ADDENDUM
NO. 2

October 31, 2023

HANOVER COMMUNITY SCHOOLS - JANE BALL ELEMENTARY RENOVATIONS AND HIGH SCHOOL IMPROVEMENTS

SHEET A-103

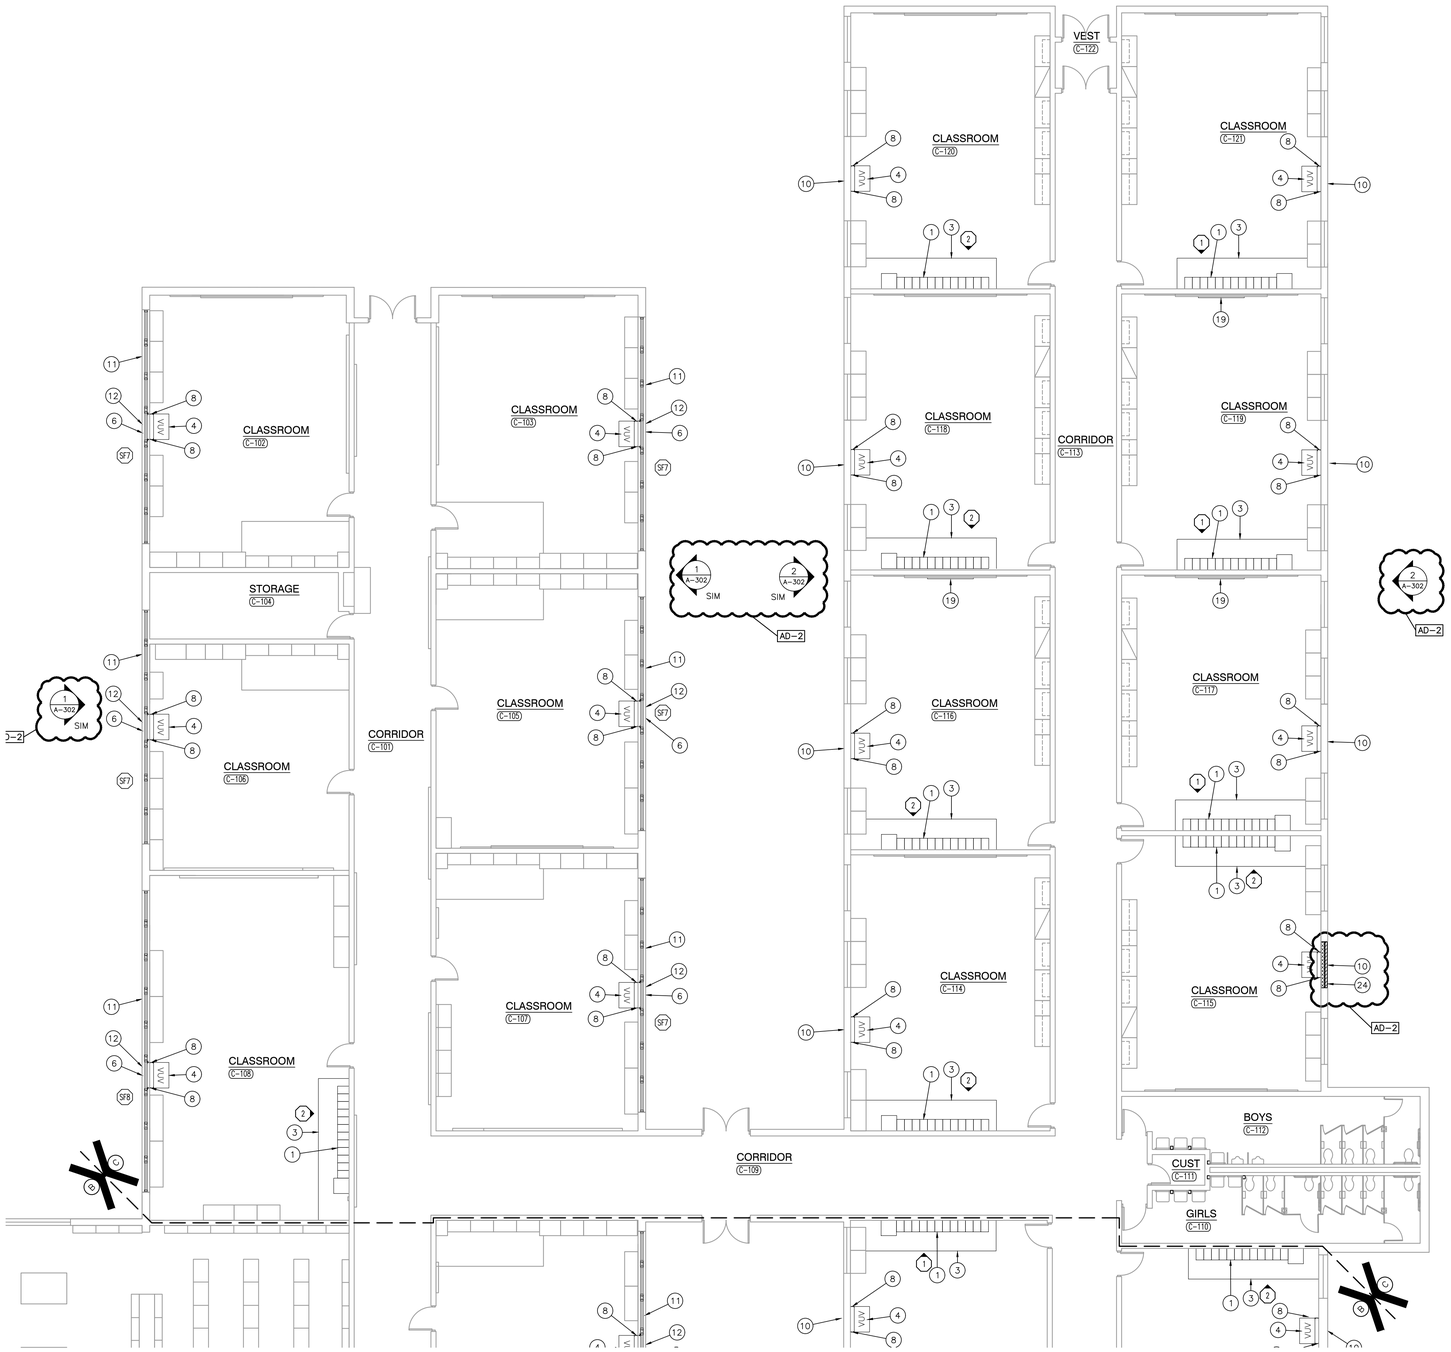
1. Revise Plan note 22 and add plan notes 23-24.
2. Add elevation callouts.
3. Infill existing window opening at Classroom C-115.

SHEET A-302

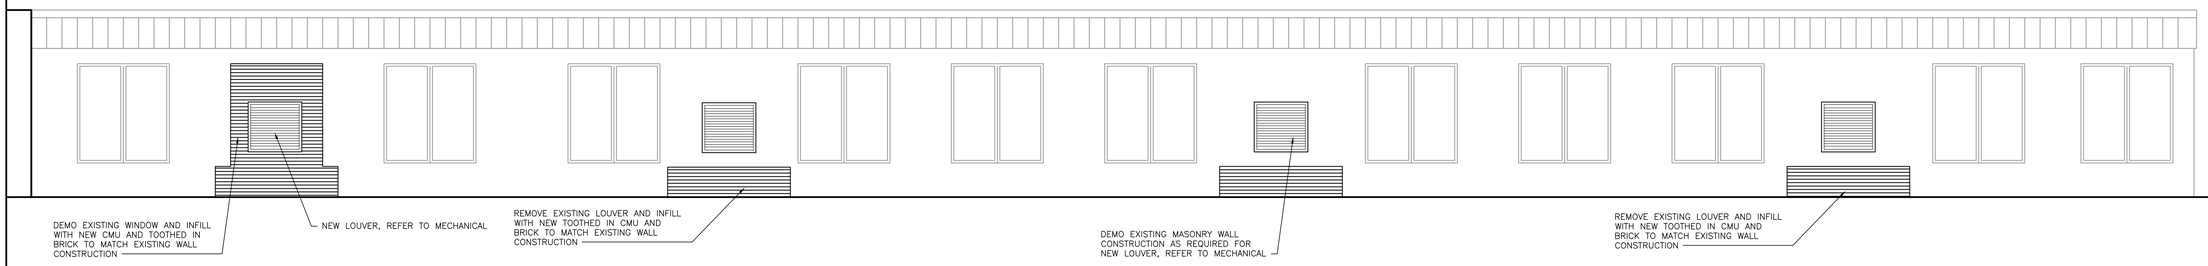
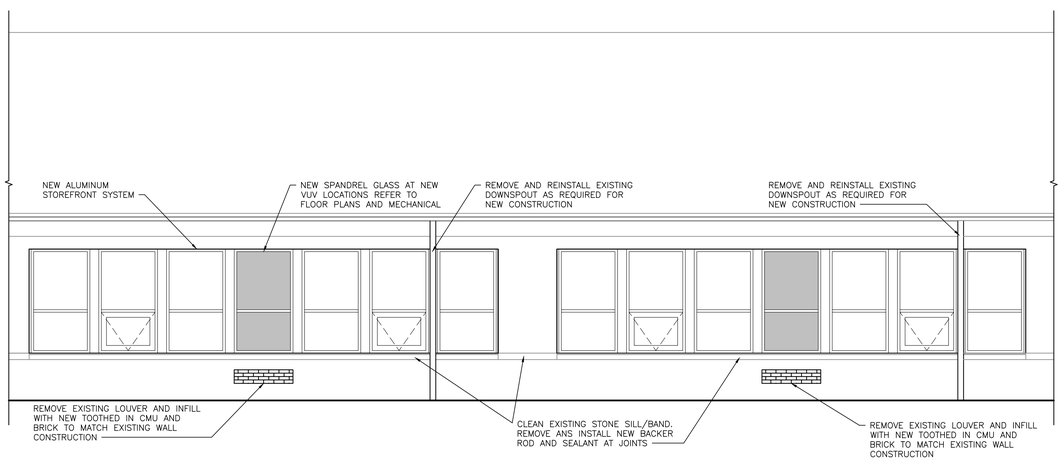
A. Refer to new full-size drawing, included in this Addendum for new exterior elevations showing new louvers and masonry infill.

SHEET A-402

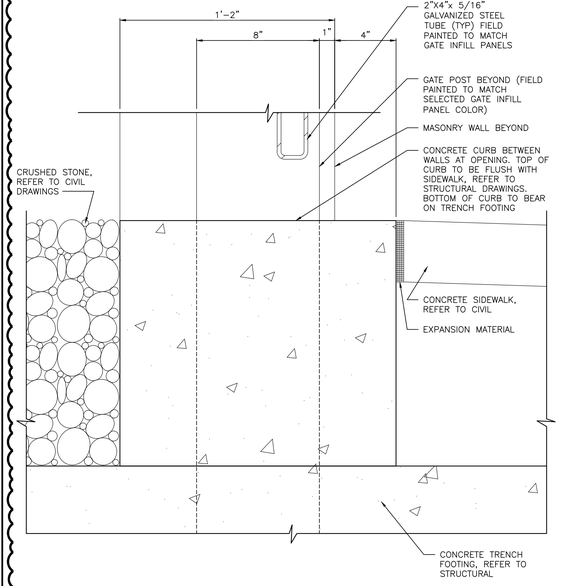
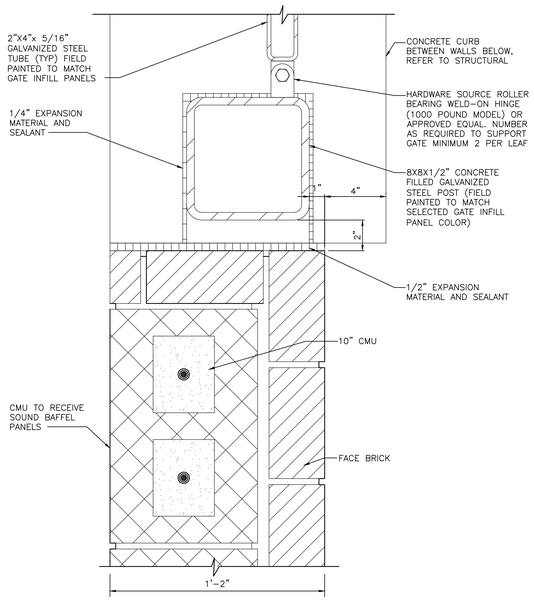
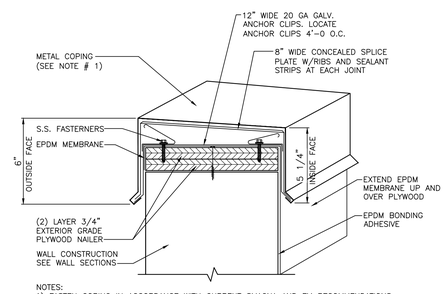
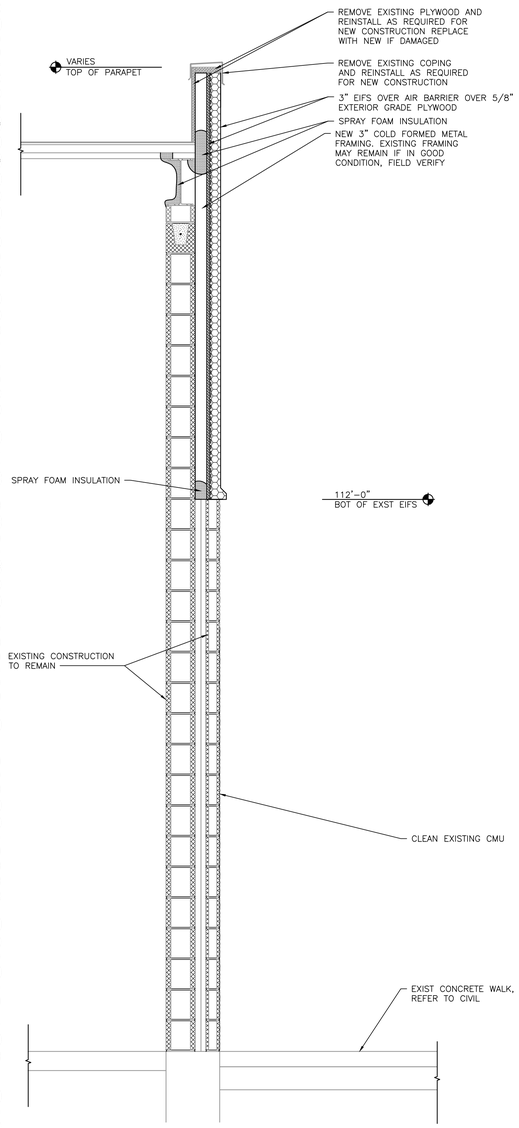
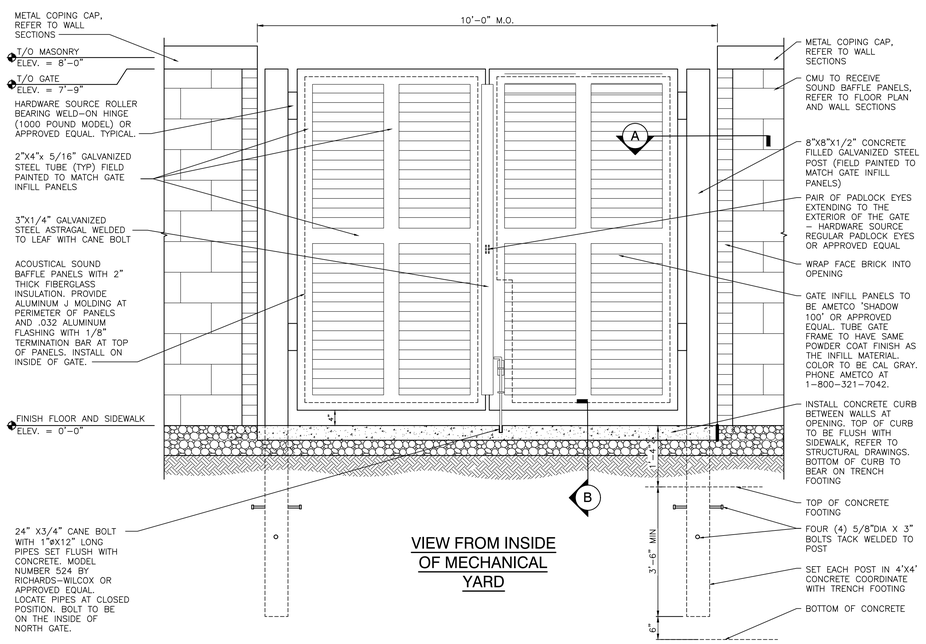
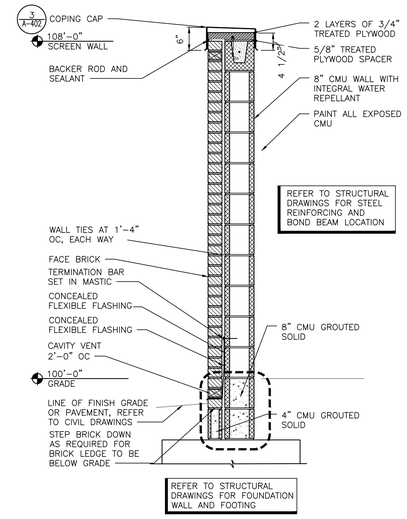
A. Refer to revised full-size drawing, included in this Addendum for the addition of wall section 2/A-402, coping detail 3/A-402, and mechanical yard gate elevation and details 4/A-402.

WALL SECTION @ WINDOW & UNIT VENT
SCALE: 3/4" = 1'-0"
(3 / A-501)

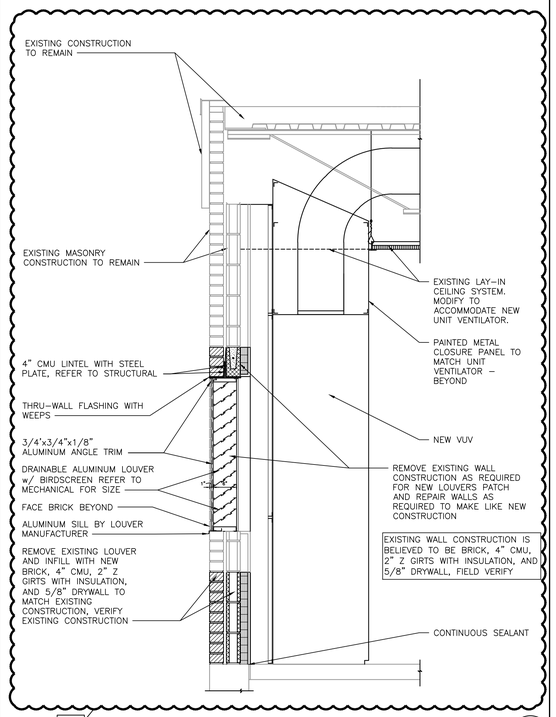
A. Refer to revised full-size drawing, included in this Addendum for revisions to wall section 3/A-501.

SHEET A-801

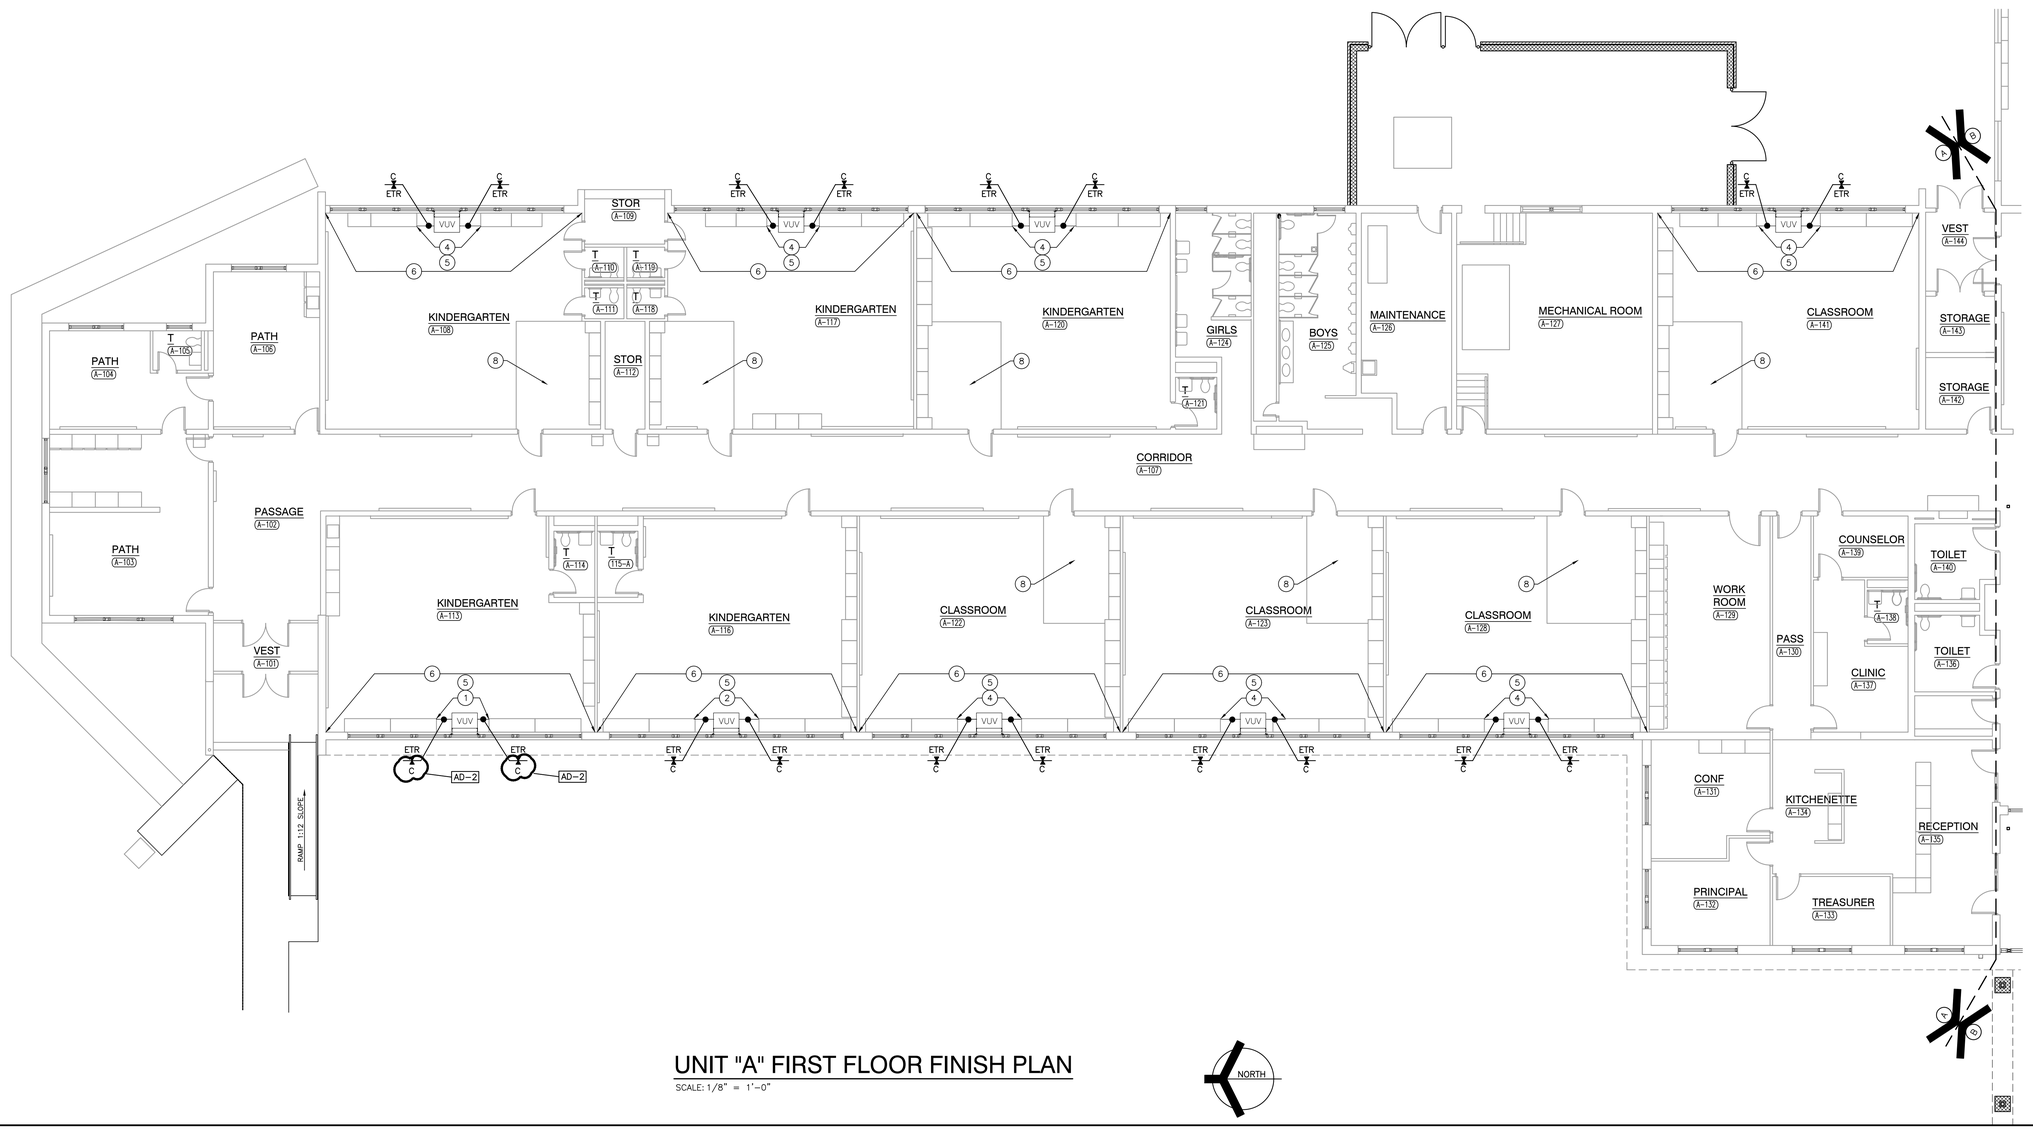
1. Plan Note change. Change VCT to Carpet for room A-113.

SHEET A-802

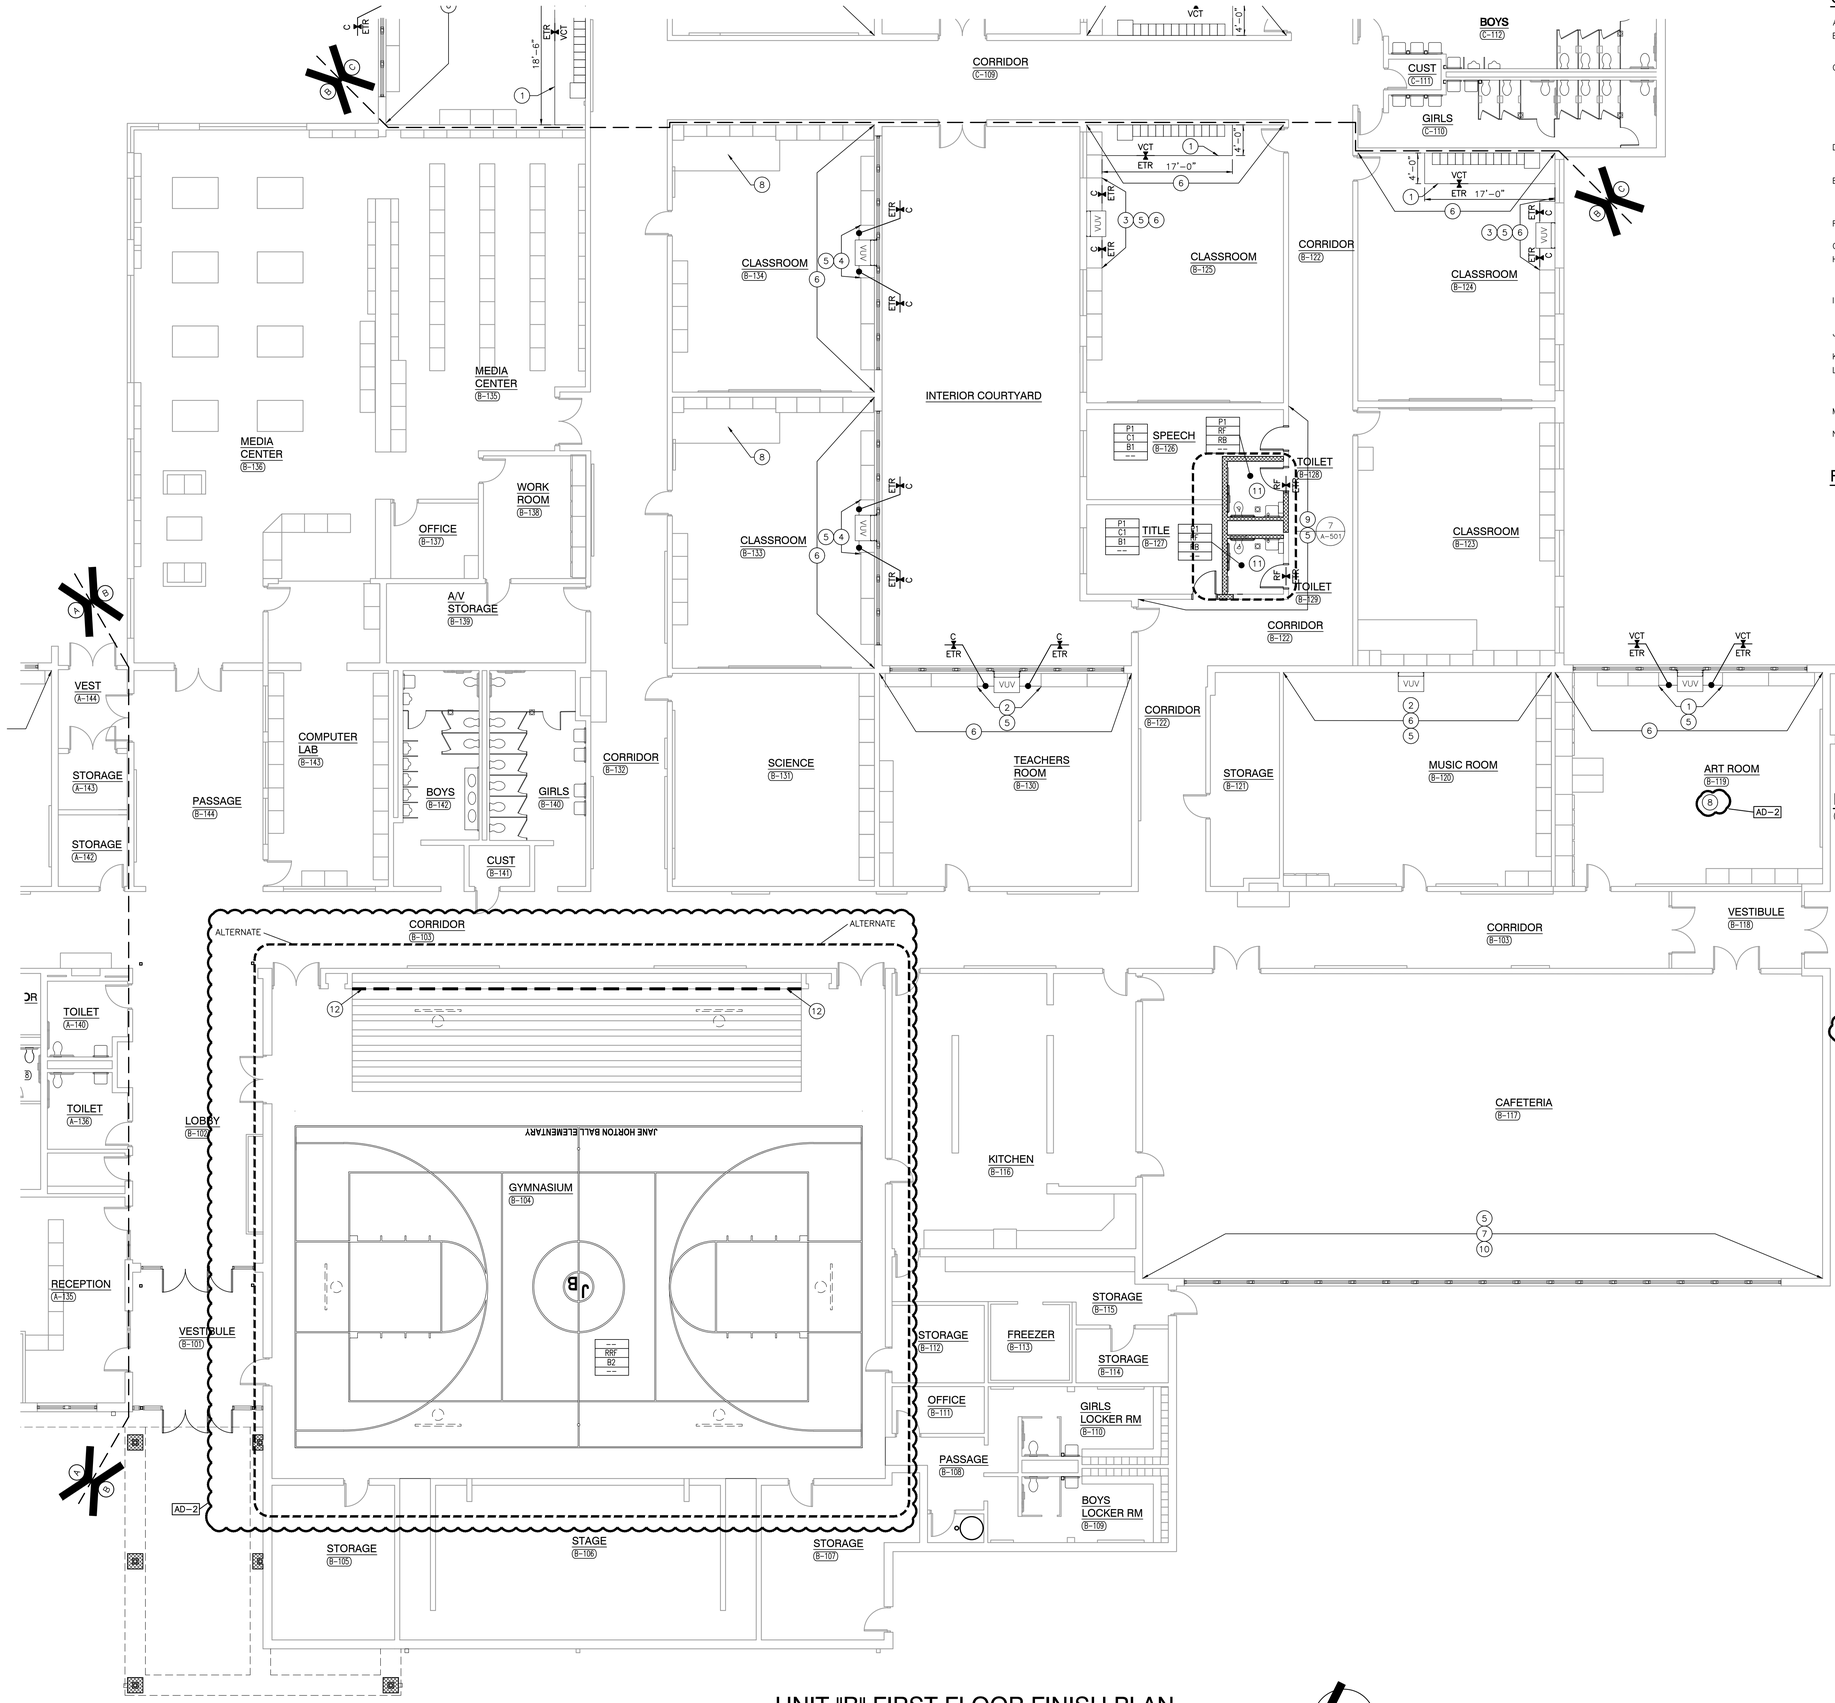
1. Plan Note Add. See Art room B-119 added keynote #8.
2. Added plan note 12.
3. Added alternate for new gym floor.
